Access Compliance Report

Public Rights-of-Way

Intersection ID: 31813	Main Street: WENDOVER_HILL_CT	Cross Street: CHURCHILL_RD	Location: NE
ADA ID: 7A70F00D5CF1	Ramp Type: BlendTrans2	Initial Pass/Fail: Fail	Overall Compliance: No
		Severity Score: 8.75

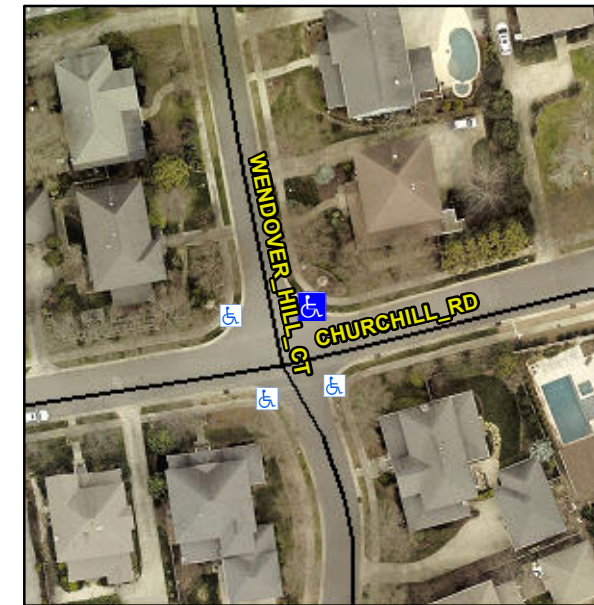
ASP LIP 1.0

Not Found, R304.5.1

Remove & Replace Curb Ramp With Two New Directional Ramps or Equivalent.
